ORDER FOR LOCATION OF CONDUITS AND MANHOLES

ASTAR EVERSOURCE
 Utility Division
 100 MASSACHUSETTS AVE. BOSTON, MASS. 02108
 Plan of CONCORD ST., FRAMINGHAM
 Showing PROPOSED CONDUIT LOCATION

Re: 82 Concord Street - Grant of Location Request – Eversource Electric Conduit

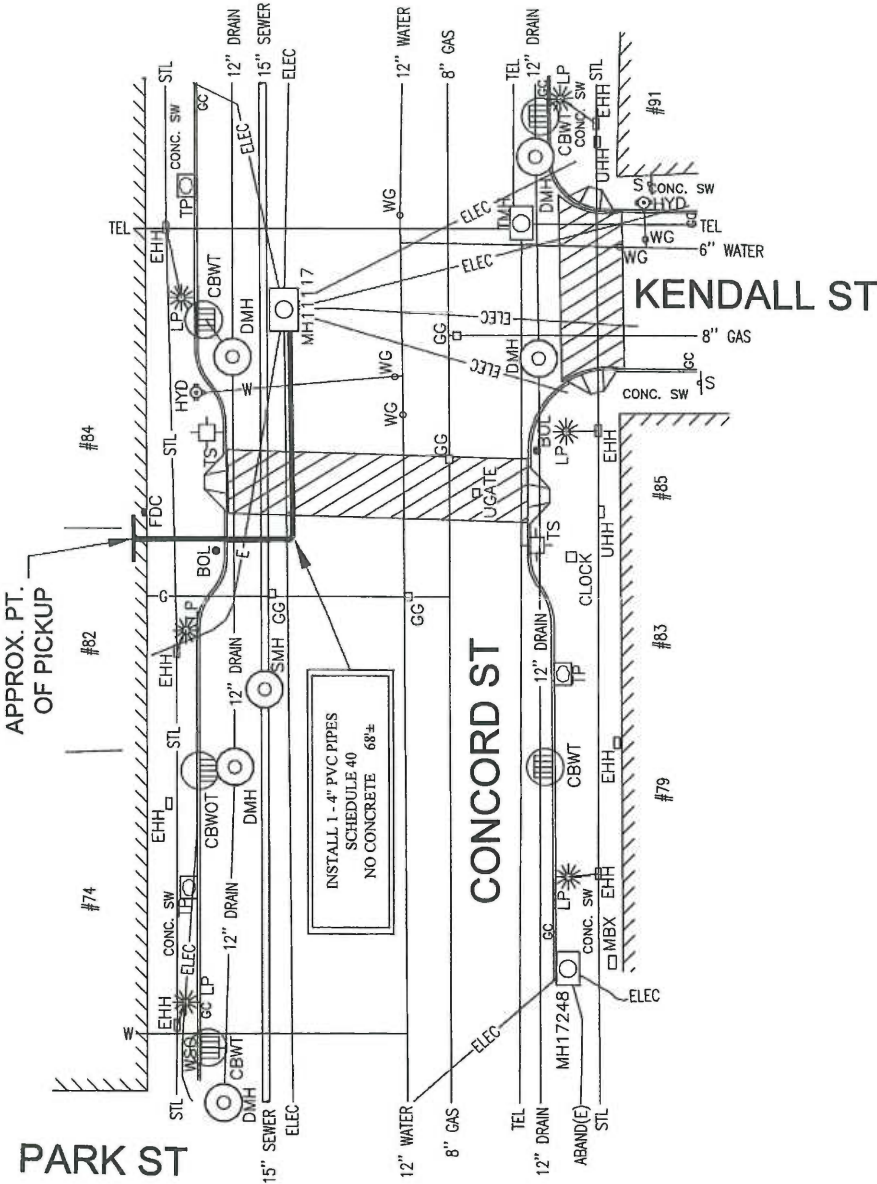
1. The conduit shall be encased in cement concrete.
2. This segment of Concord Street was recently paved (less than 5 years) heighten roadway restoration shall be applied at the time of Street Opening Permit issued.
3. The applicant shall obtain a Street Opening Permit and a Trench Opening Permit for this work.
4. DPW requests notification prior to the start of work to verify final location in the field and that no public utilities are adversely affected.
5. The applicant and contractor shall endeavor to maintain 10-foot separation from town-owned utilities at all times.
6. The applicant shall submit a traffic management plan to DPW for review and approval prior to construction.
7. The applicant shall fully replace and restore all sidewalk, curbing, and roadway infrastructure impacted by this work.
8. All work shall conform to the City of Framingham construction standards.
